PLAN COMMISSION REPORT

Proposal: Plan Review – Pay Kiosks, Trash/Equipment Enclosures

Address(es): 6900 S. 27th St. (2nd Aldermanic District)

1 CONCEPT SITE PLAN

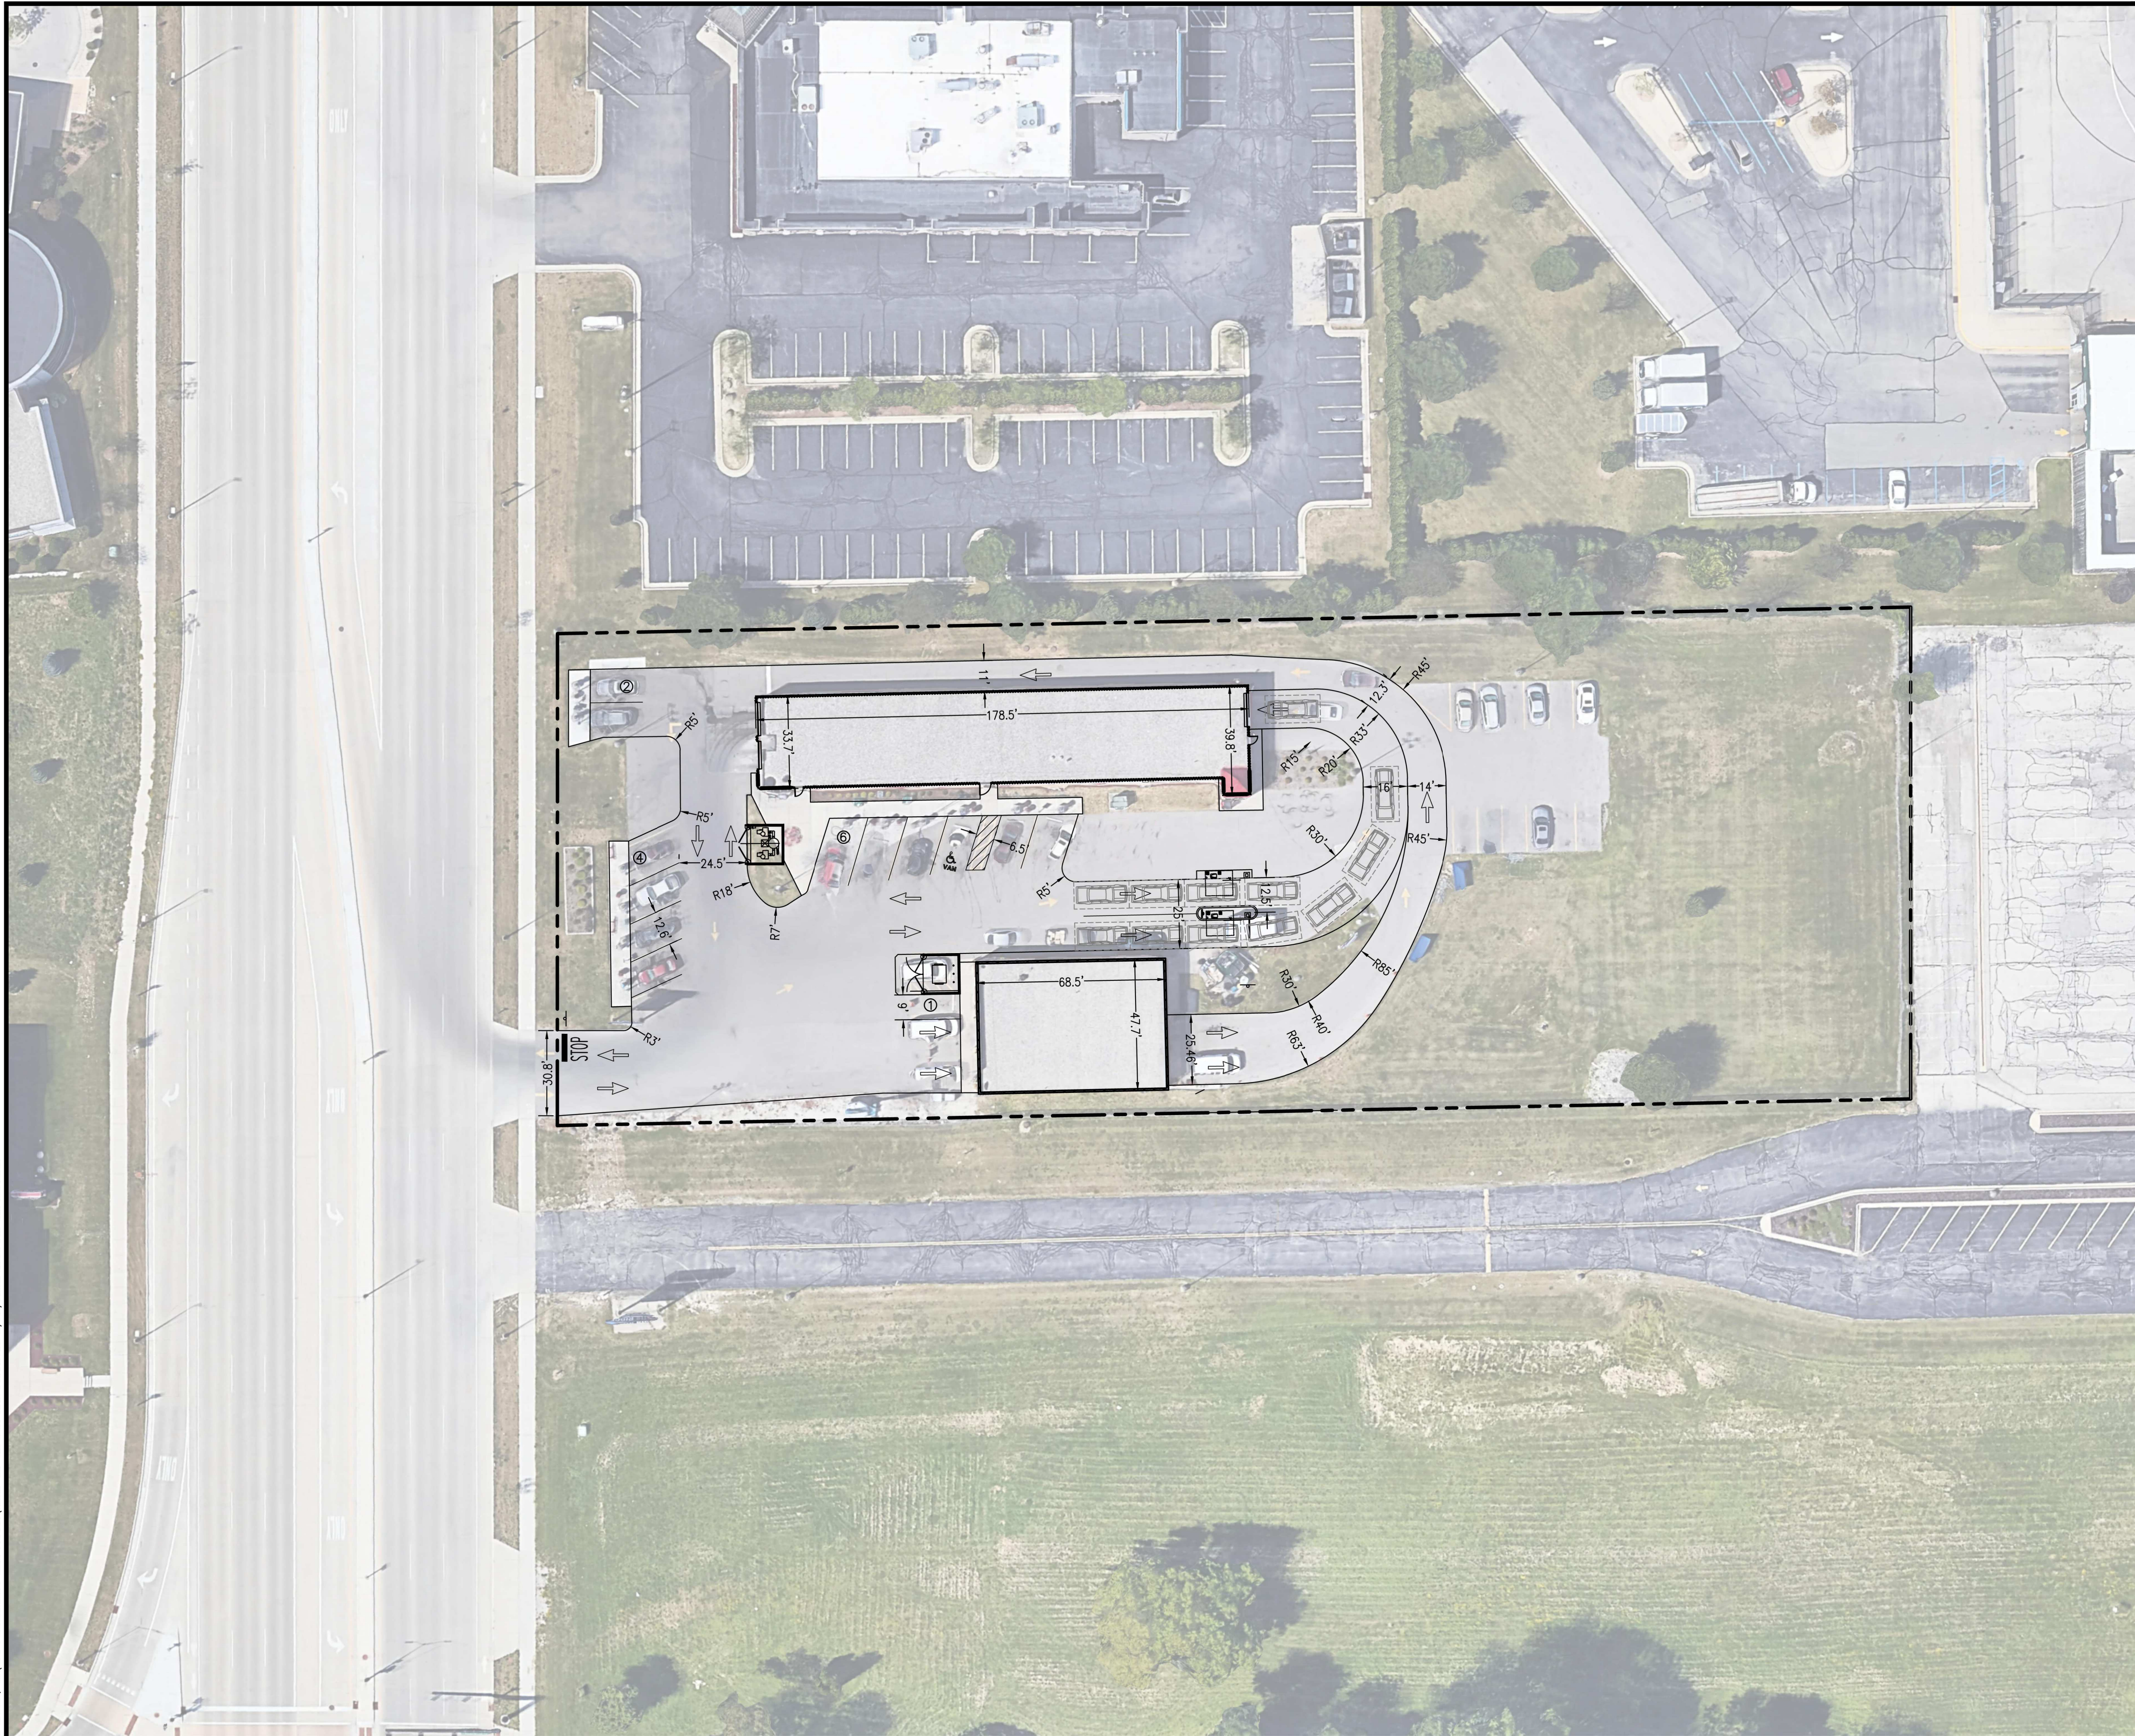
The Applicant is requesting approval for two (2) pay kiosks, a trash enclosure, and an equipment enclosure on the property at 6900 S. 27th St. This property was approved for a Conditional Use Permit for a car wash per Ord. 1617, amended in 1994 to allow for an additional automotive oil and lubricating services use. Copies of those Conditions and Restrictions are included with this report for reference. However, staff note that the addition of two (2) parking stalls with vacuums in the location of the former driveway on the north, which was eliminated with the WisDOT 27th Street project in 2016, were never reviewed and approved by the Plan Commission. This is concerning as the parking stalls and vacuum appurtenances do not meet setback requirements.

Per Code, car wash drive-throughs are required to provide a minimum of five (5) stacking spaces of 20-foot depth each in lanes that are a minimum of 10 feet wide. Stacking spaces may not impede parking areas or public entrances to buildings. It appears from the submitted site plan that three (3) vehicles are accommodated prior to the pay kiosk, two (2) are accommodated just past the gates at the end of the pay kiosk island, and at least four (4) vehicles in a single-lane configuration are accommodated before the entrance to the car wash. Code also limits the total cumulative area of all menu boards to a maximum of 100 square feet. Details for the proposed menus were not included with the submitted plans; therefore, staff cannot determine whether the proposal meets Code requirements.

Sec. 17.0506(a)(12) states that enclosures “shall not occupy areas used for required parking spaces.” The proposed trash enclosure on the west side of the oil change building will remove one (1) parking stall. Current Code would require a minimum of 12 parking stalls for the site, which would still be exceeded in the proposed

plan. It will be at the Plan Commission's discretion whether the reduction of one (1) stall and the locations of the enclosures are acceptable.

- A complete site plan with setbacks and dimensions for all proposed site modifications.
- Details for the menu boards, including design and dimensions.
- Lighting plans for the kiosks and any other site lighting modifications.
- Dimensions for the enclosures.
- Landscaping plans for the site.
- Elevations for any exterior modifications to the existing buildings.

3 VACUUM EQUIP. ENCLOSURE ELEVATIONS
1/4"=1'-0"

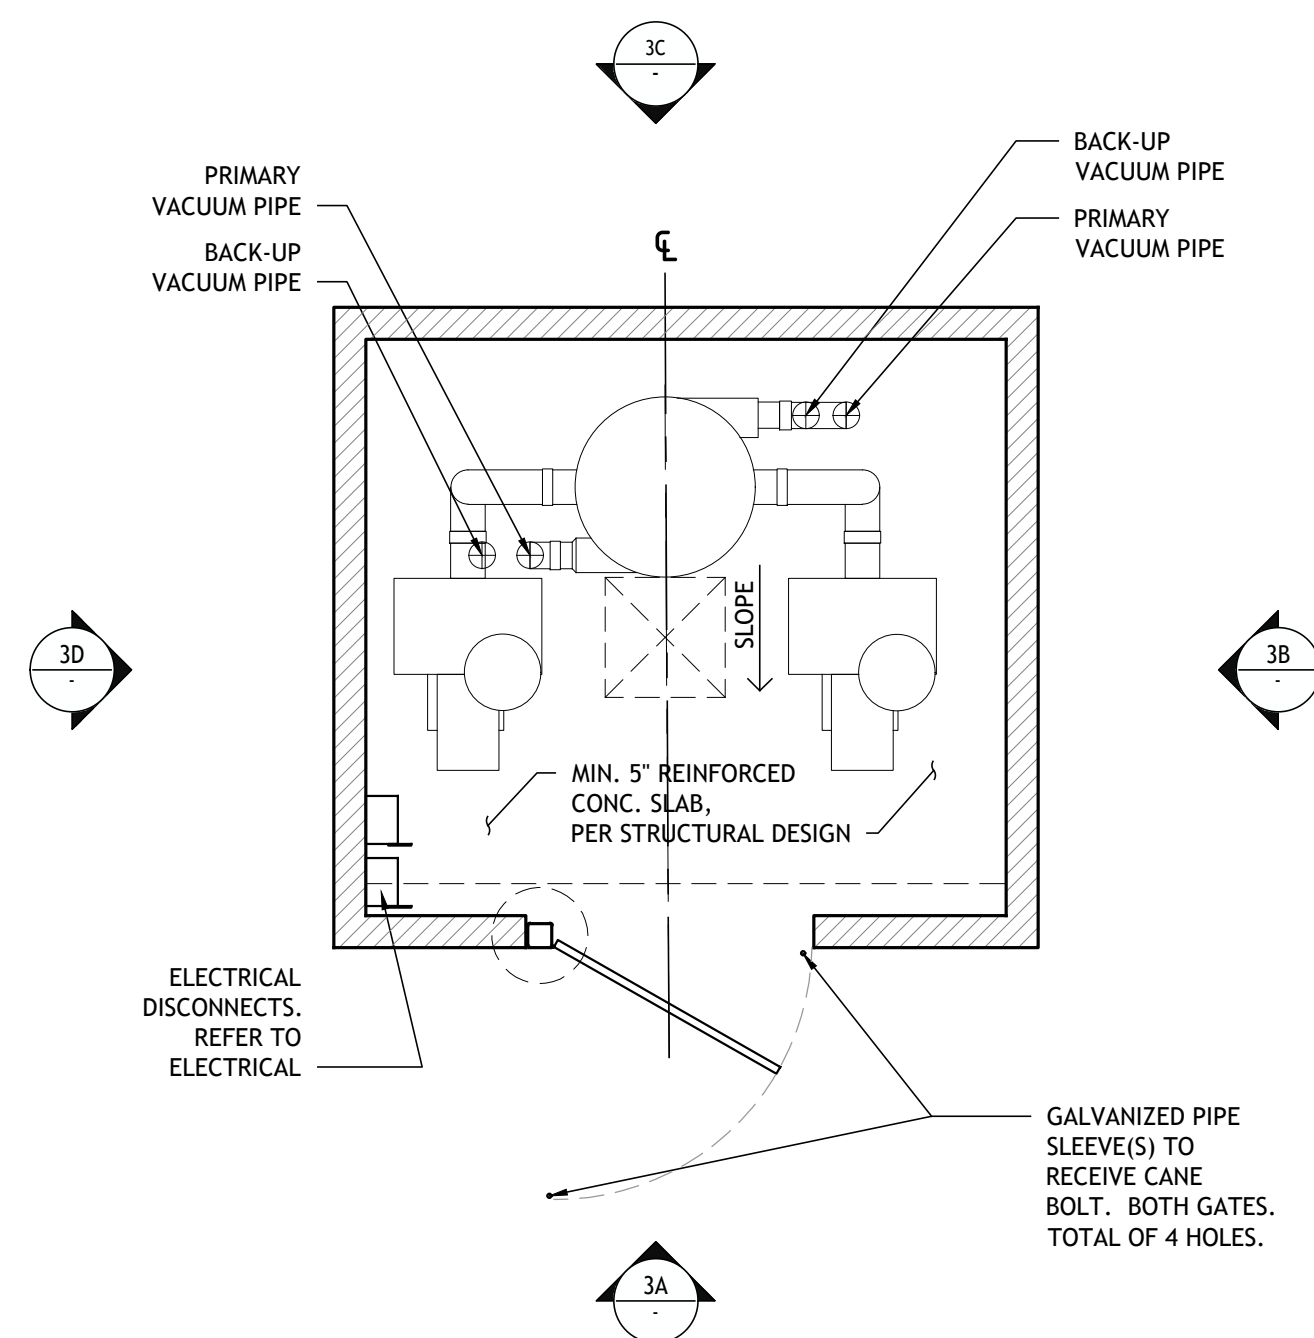
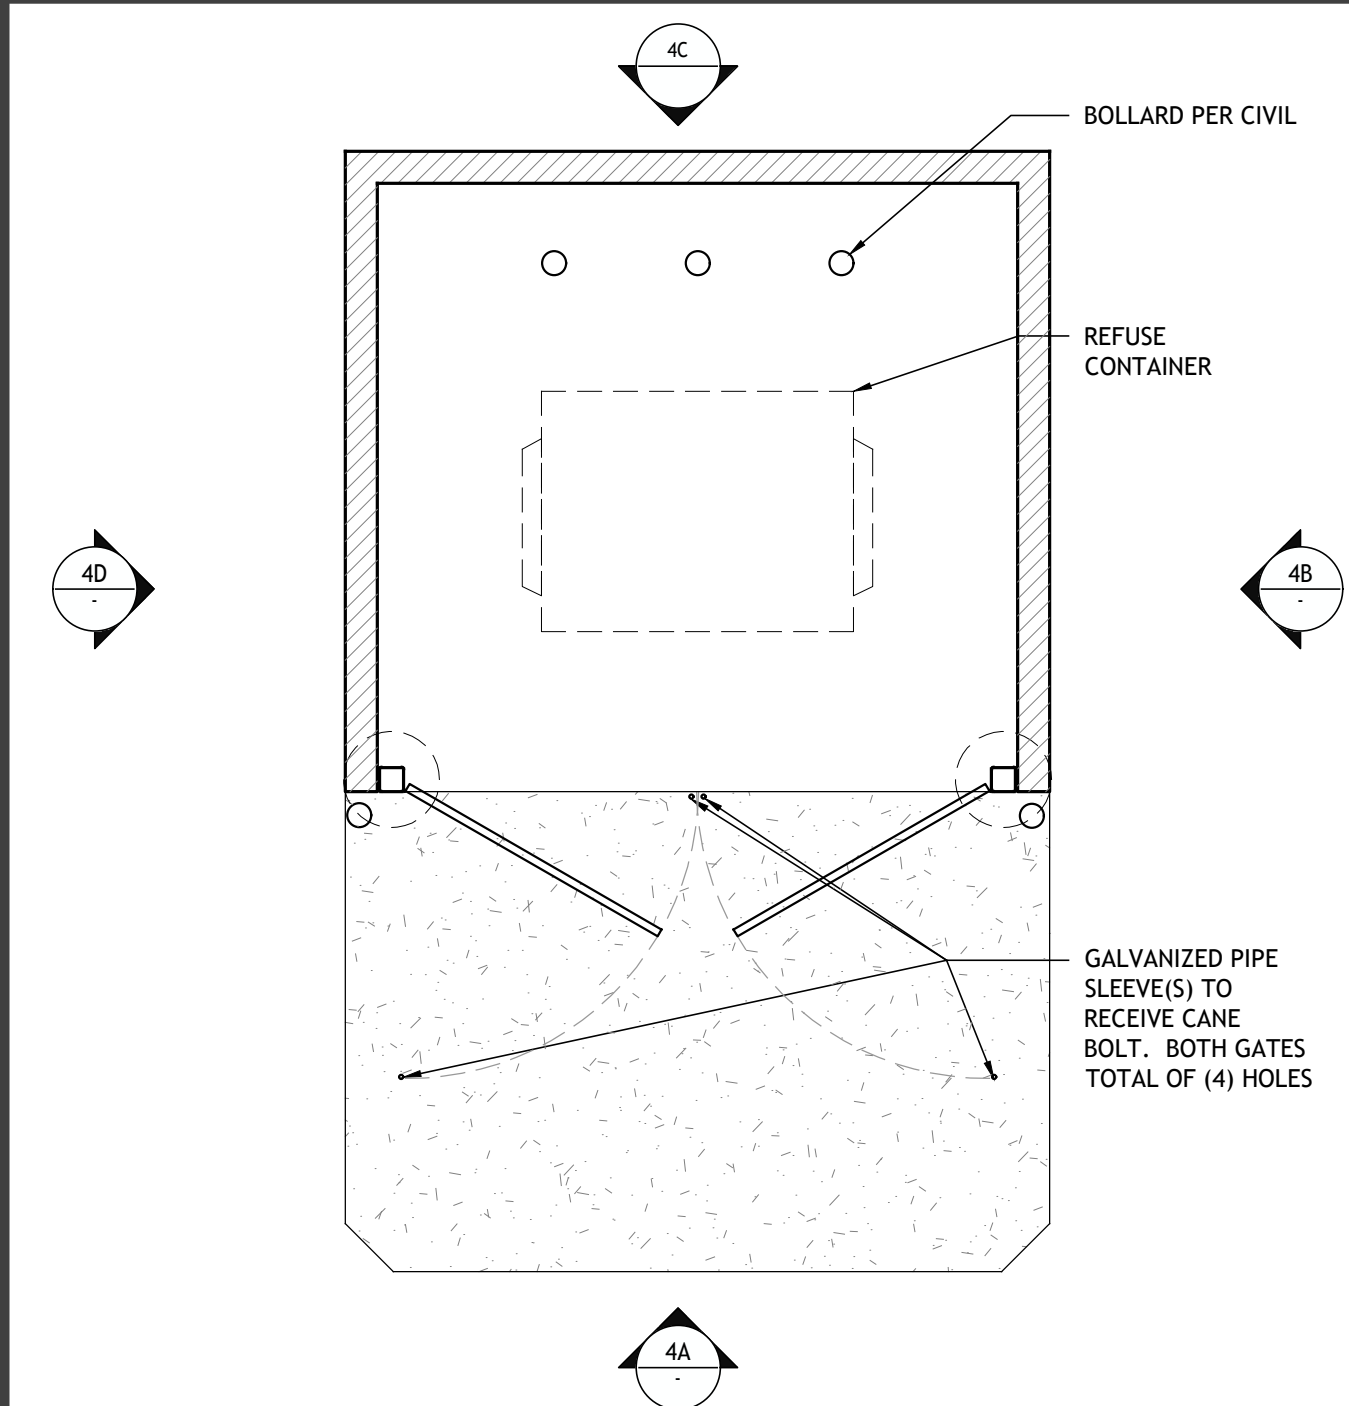
Finally, two (2) enclosures are proposed: a vacuum equipment enclosure is shown on the west side of the car wash parking stalls, and a trash enclosure is shown on the northwest corner of the oil change building. Both are proposed to be constructed with CMU block and metal gates. No dimensions have been provided, nor have landscape plans been submitted. Therefore, staff cannot determine whether the proposed structures meet Code requirements. Due to the potential for the access gates to impede the drive aisles, staff recommend that the enclosure be rotated.
